**TENDER 16-20**  
**WATER TREATMENT BUILDING**

**ADDENDUM NO. 2**

**September 23<sup>rd</sup>, 2016**

**Addendum Item 1**  
**Questions & Answers**

**3 PLAN**  
SCALE: 1:250

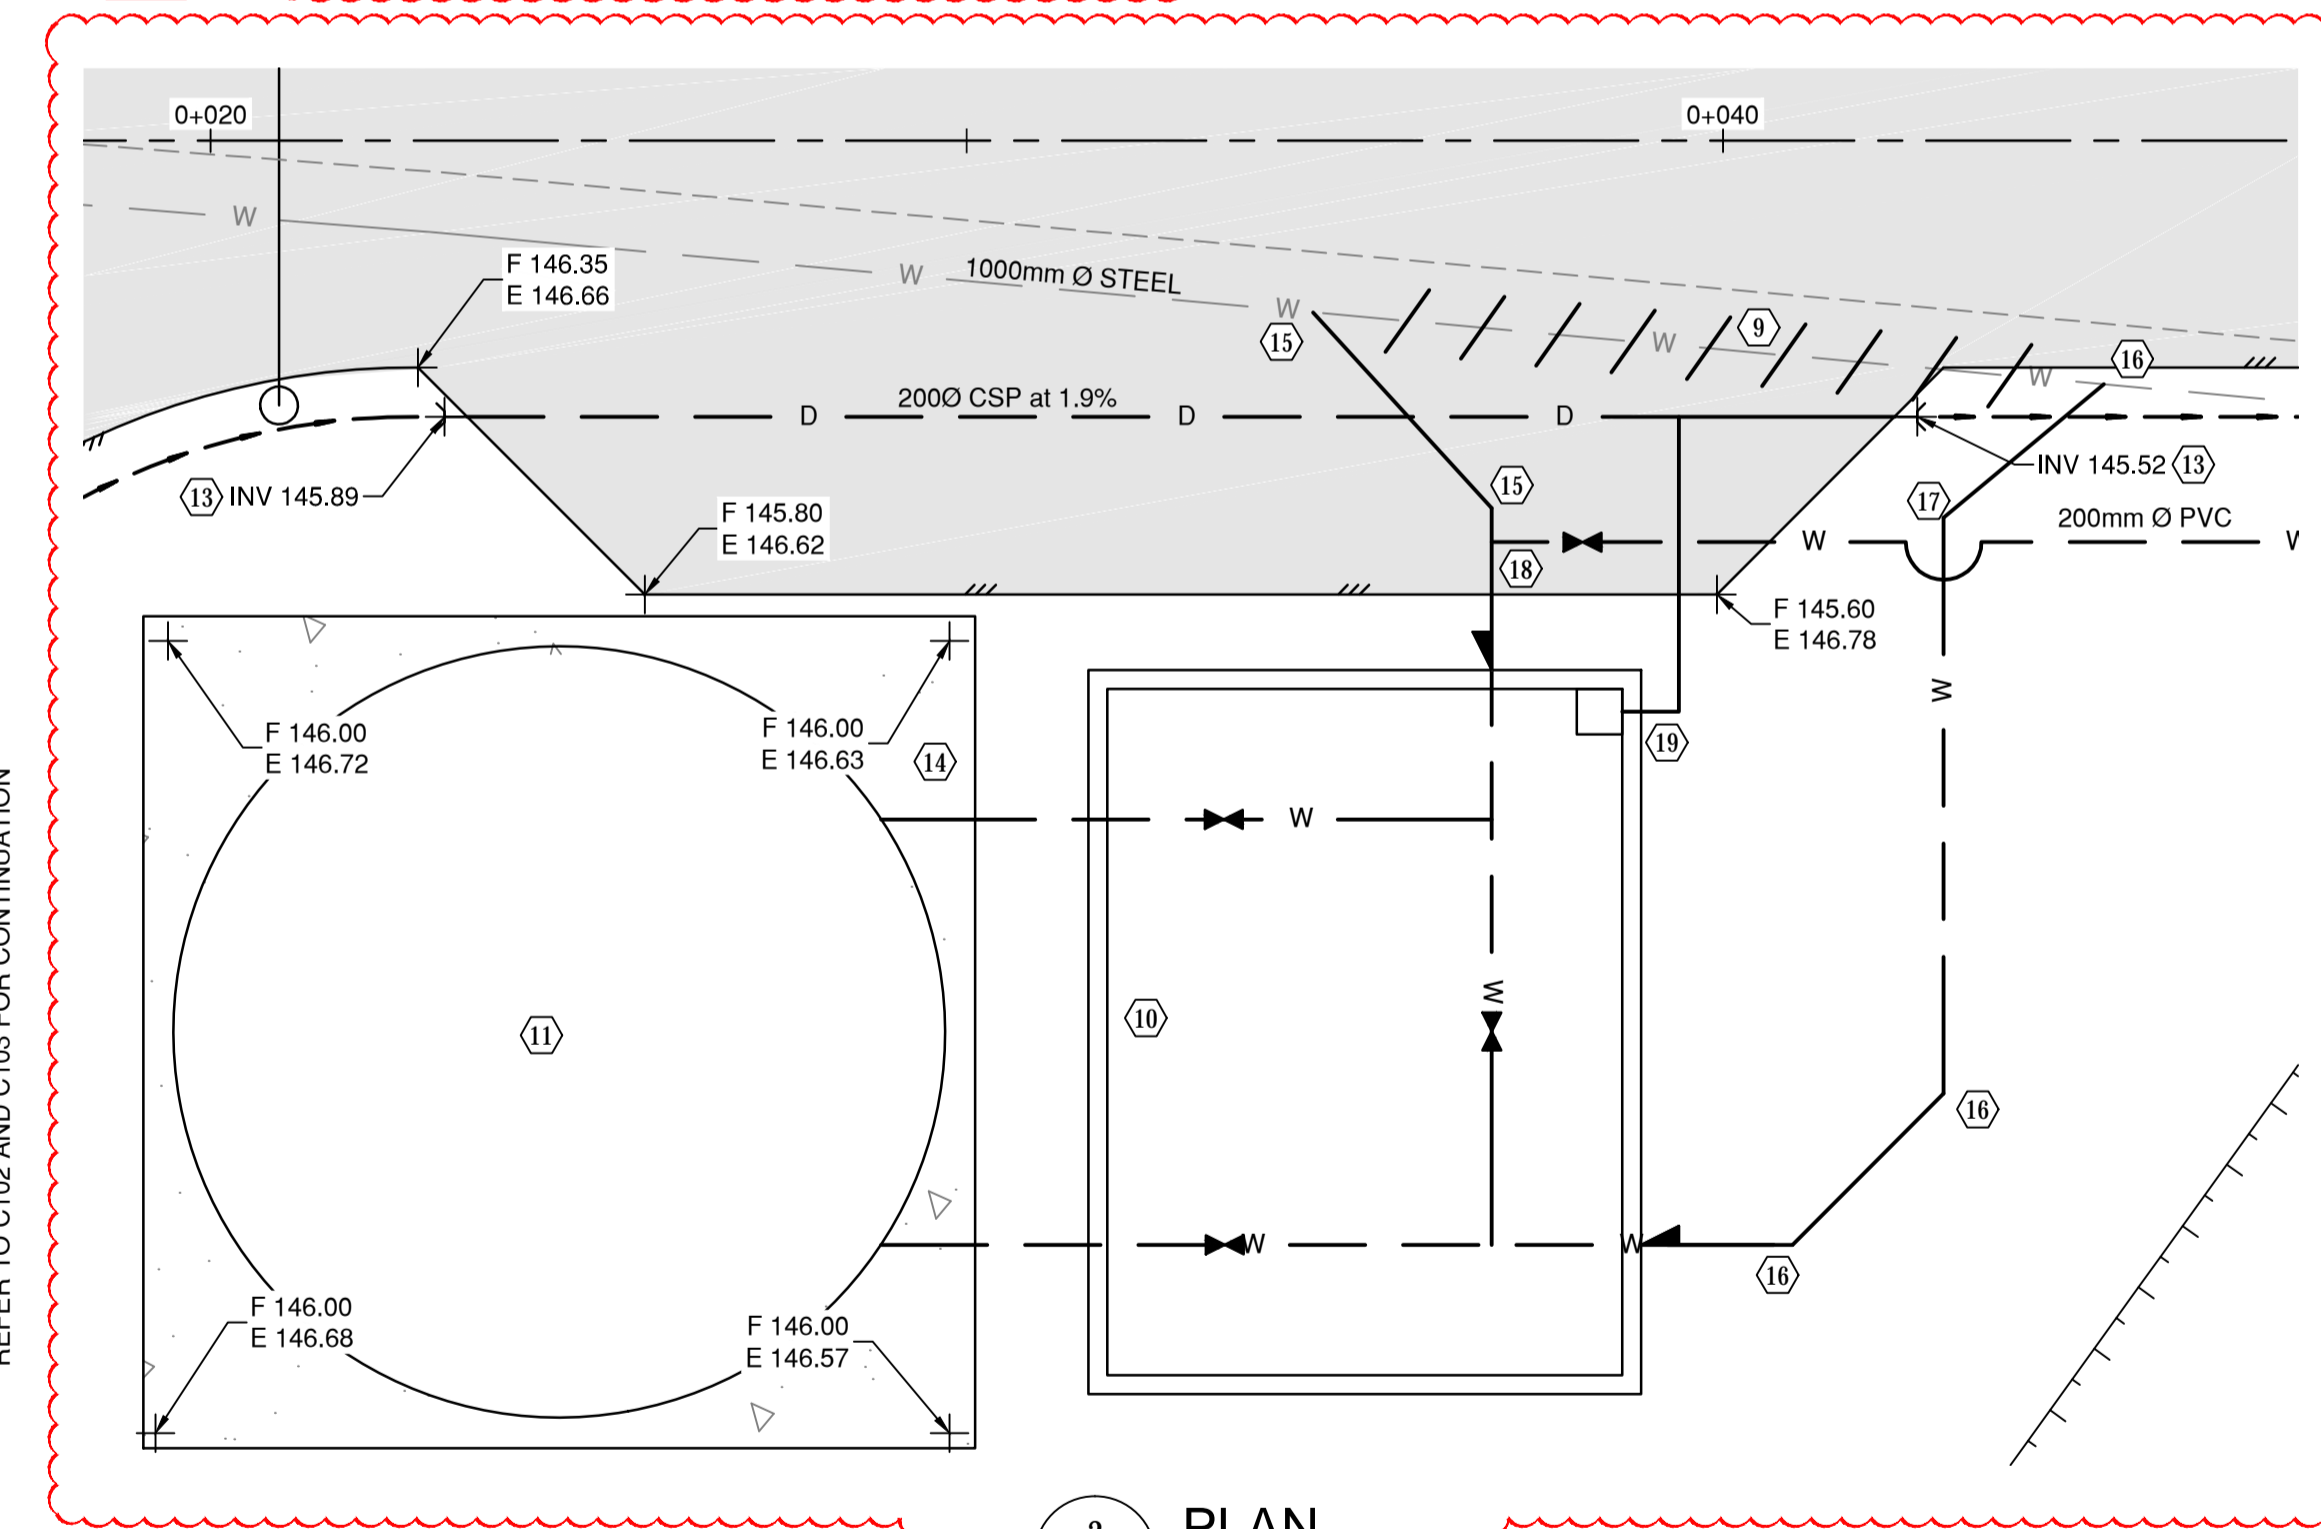
- a. S102, 105, 106 are structural drawings relating primarily to grating and trench details in the building.
- b. C201, C105 are clarifications as pipe is not owner supplied.
- c. C101, C305, S110 and S111 have been revised and/or added to the set to detail out surge tank details and the associated valve chamber.

- ⑨ REMOVE 1000mm Ø PIPE AS SHOWN
- ⑩ CONCRETE VALVE CHAMBER. FOR DETAILS REFER TO C305 AND STRUCTURAL.
- ⑪ 10.2m Ø STEEL SURGE TANK. REFER TO SPECIFICATIONS DETAILS. DETAIL CONNECTION INFORMATION TO FOLLOW IN ADDENDUM 3

TITLE: PROPOSED RAW WATER SUPPLY MAIN HIGHWAY #28 TREATMENT BUILDING - CONTRACT 2	DRAWING NO. 15-508- C105
UTILITY PROFILES	PROJECT: 112311316
	REV. 2

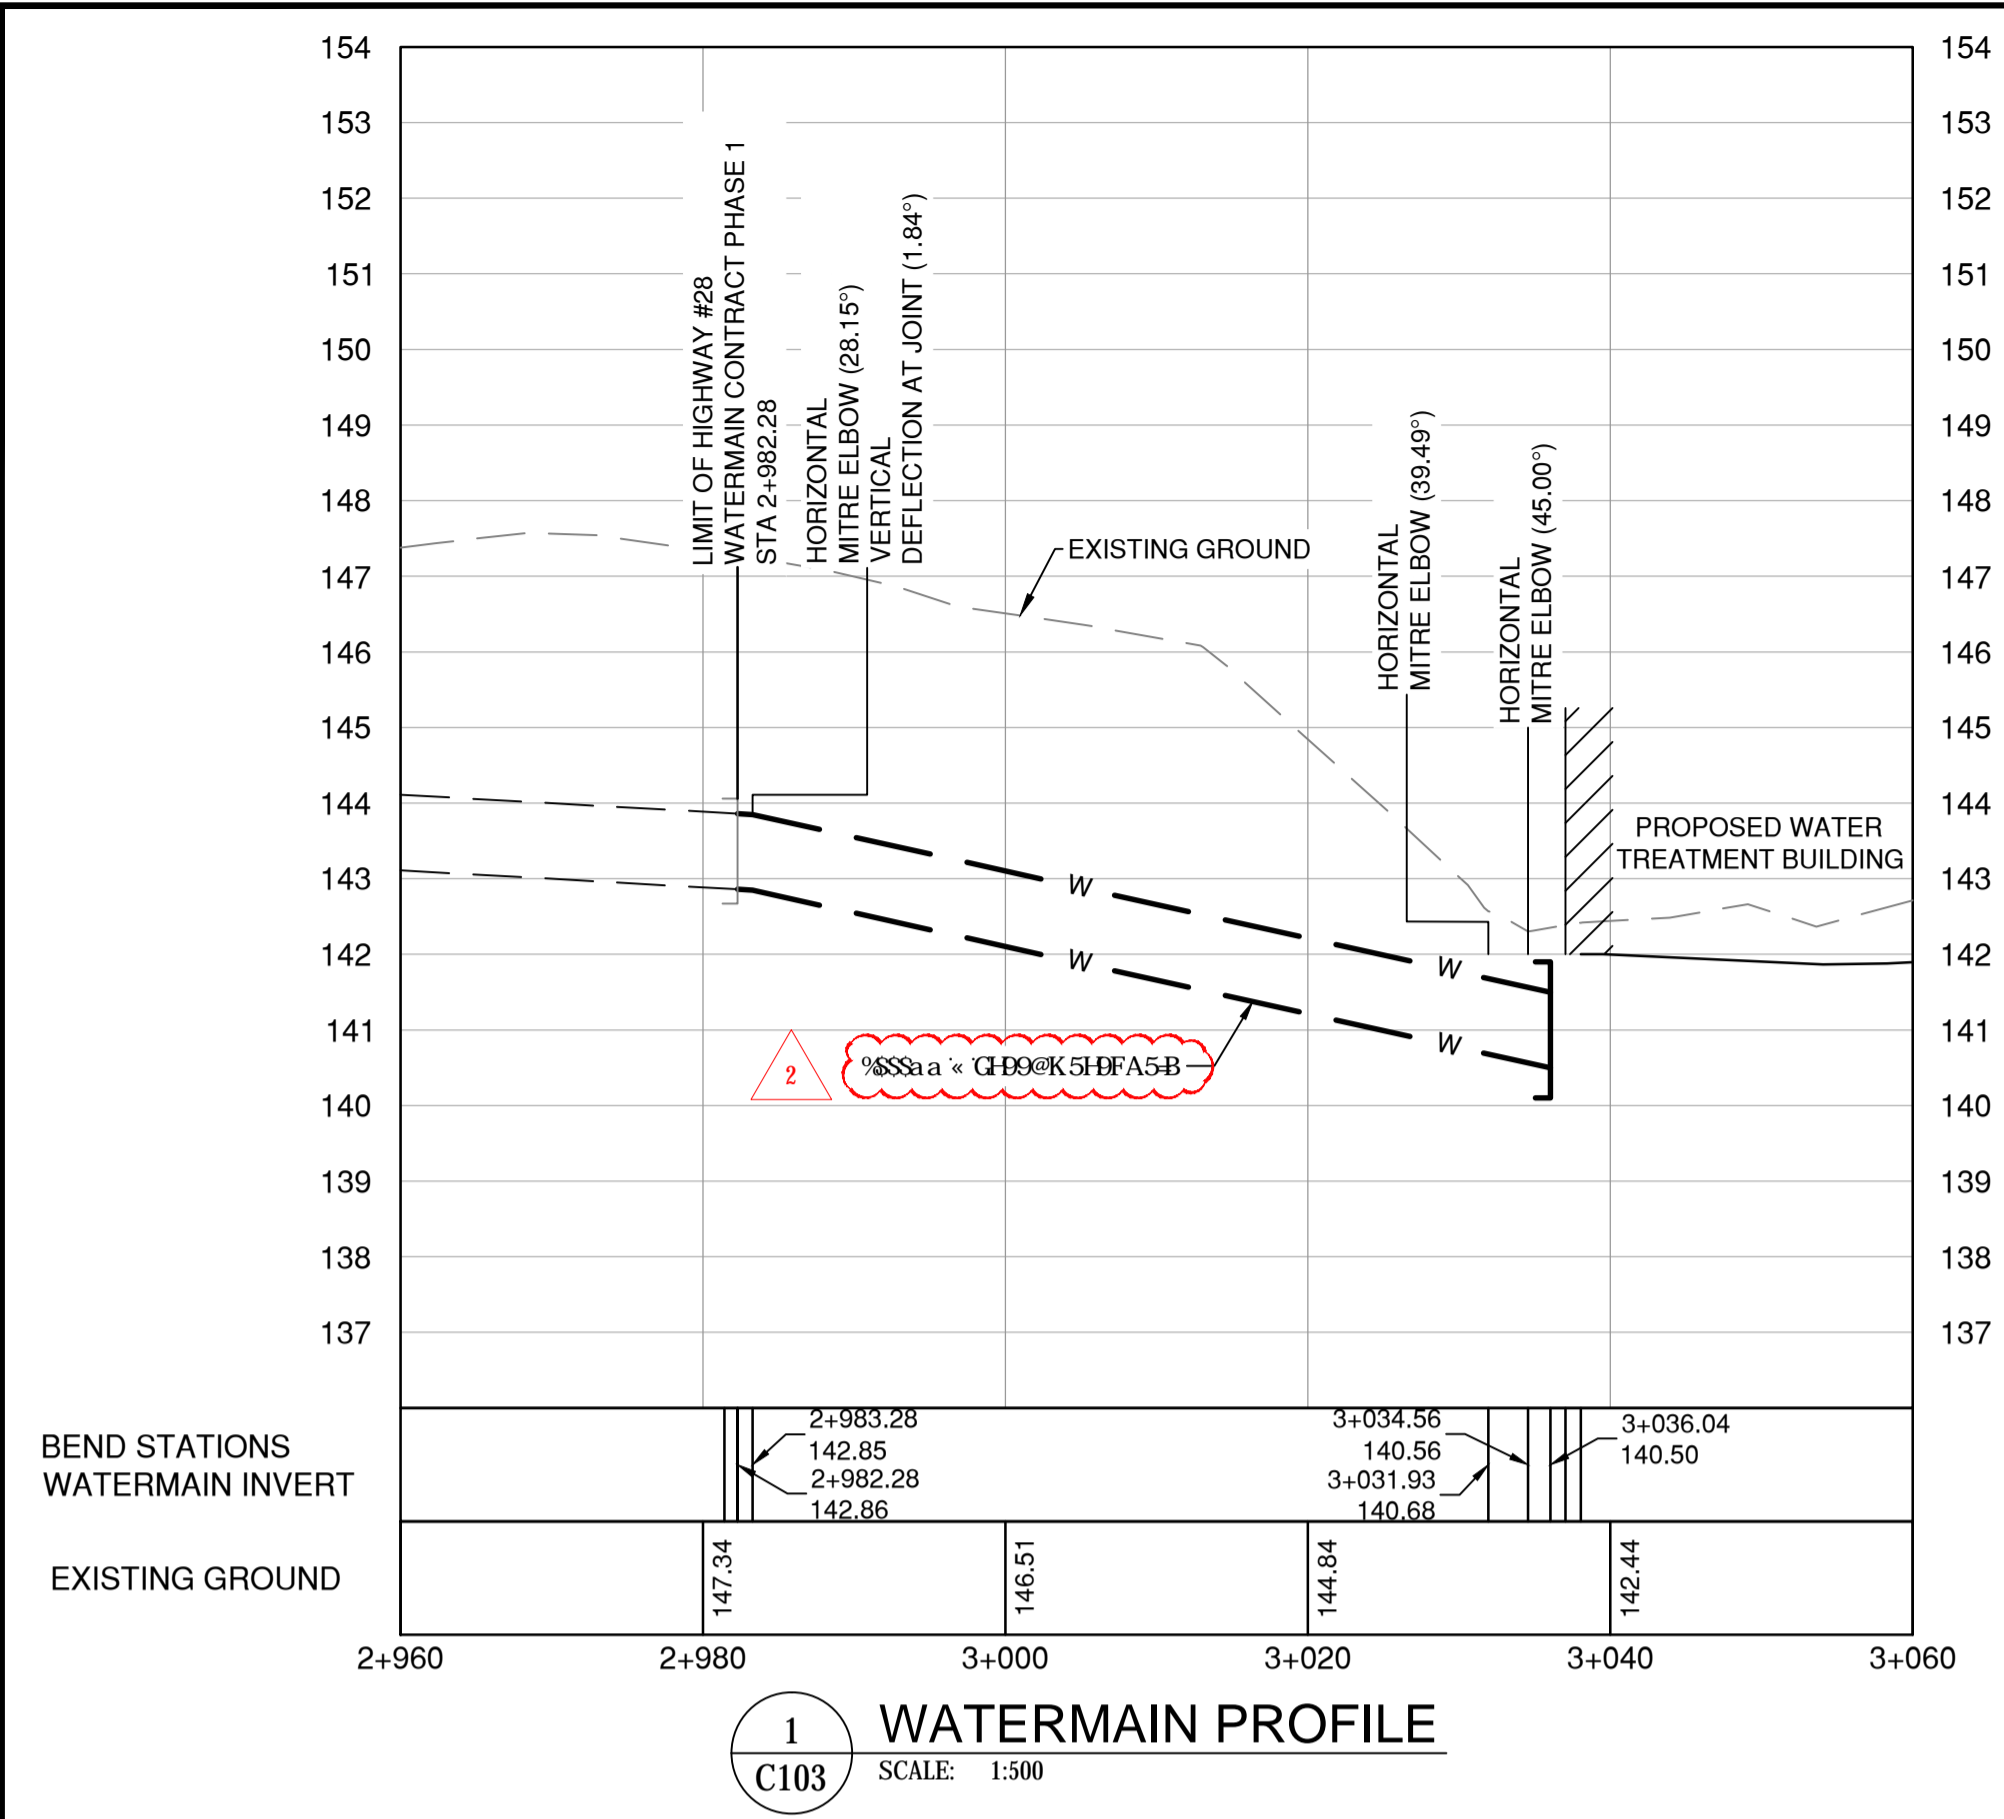
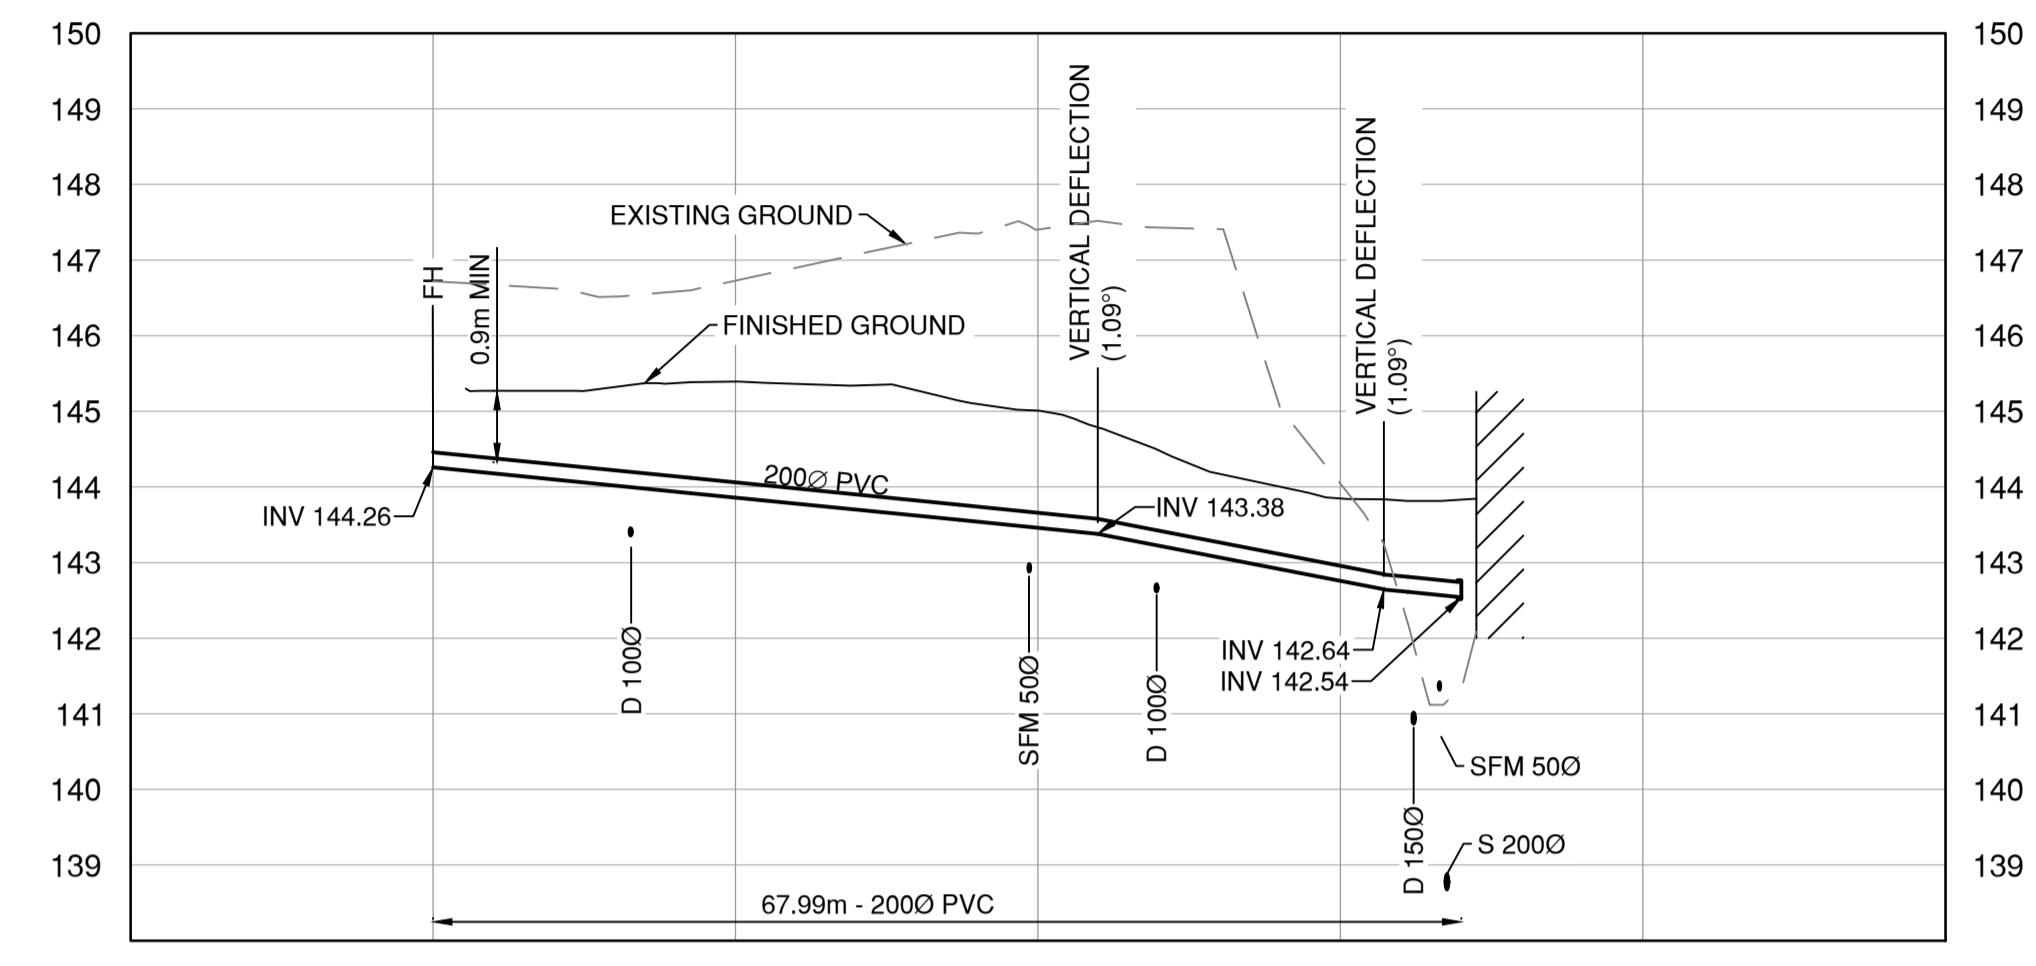
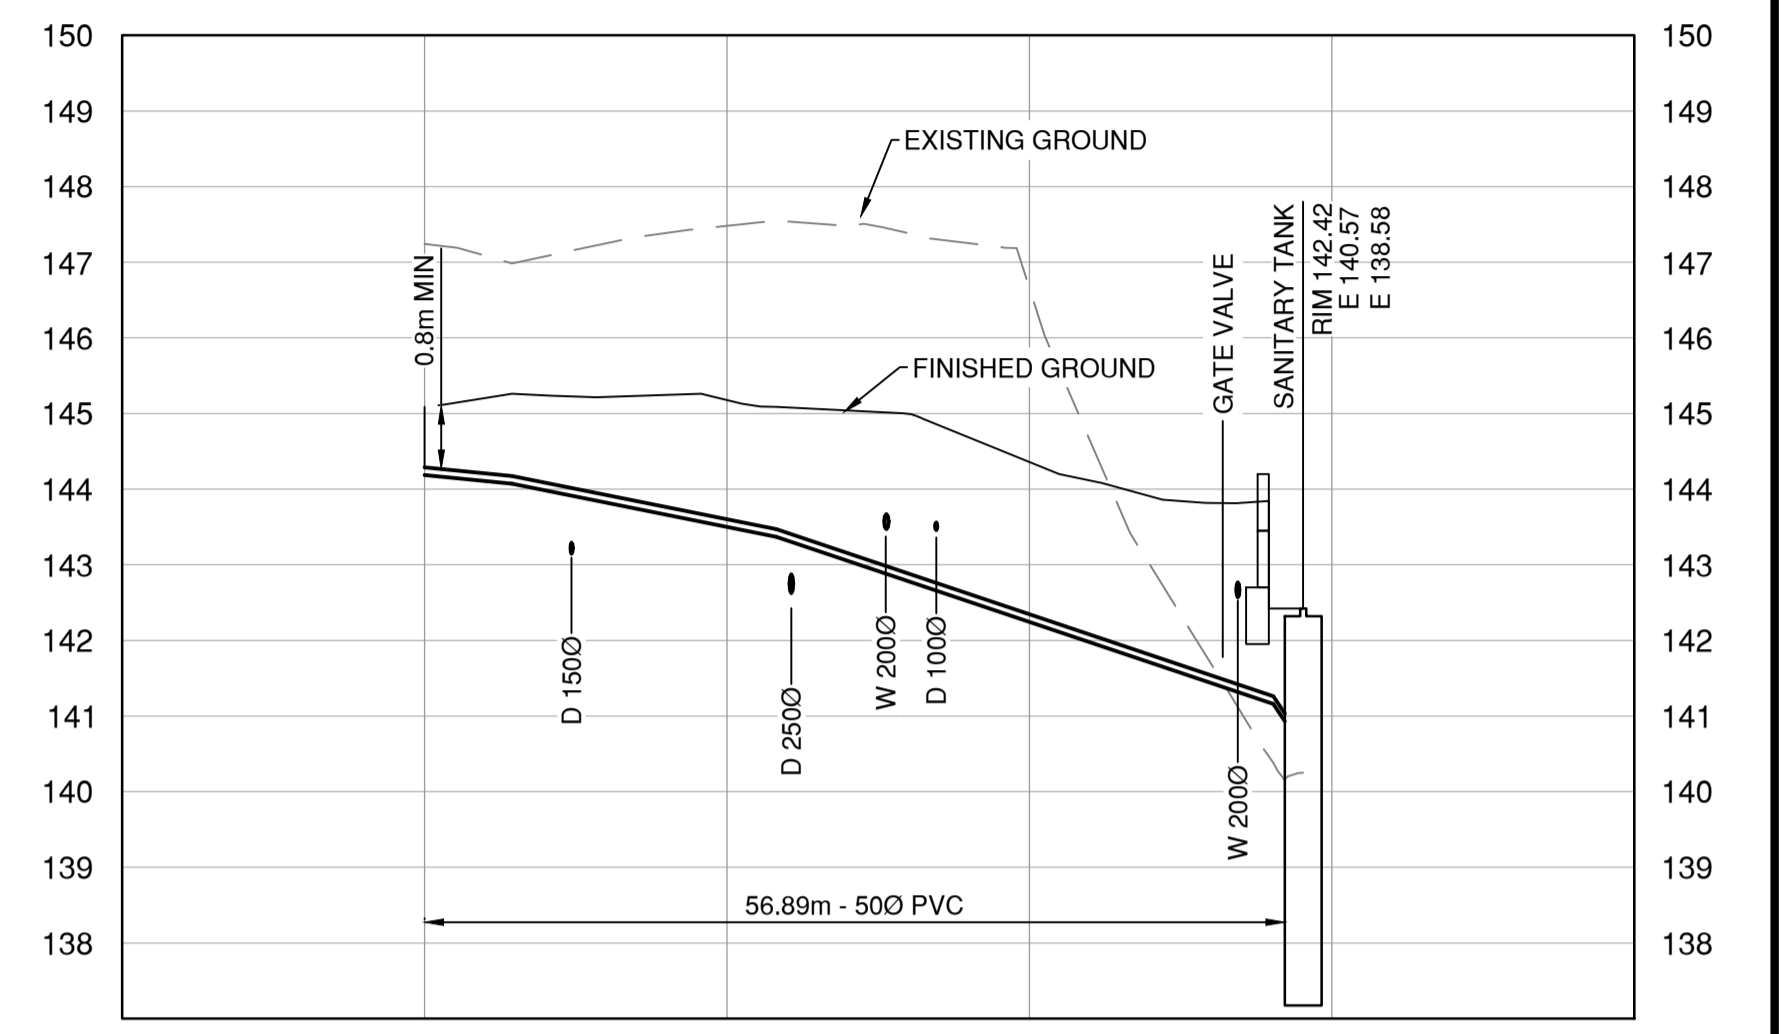
Regarding the drawings, the pipe says it is supplied by Owner - see drawings C105 detail 1 and C201 watermain profile.

The drawings have been modified to clarify that the pipe supply is by the contractor, see the revised drawings attached.
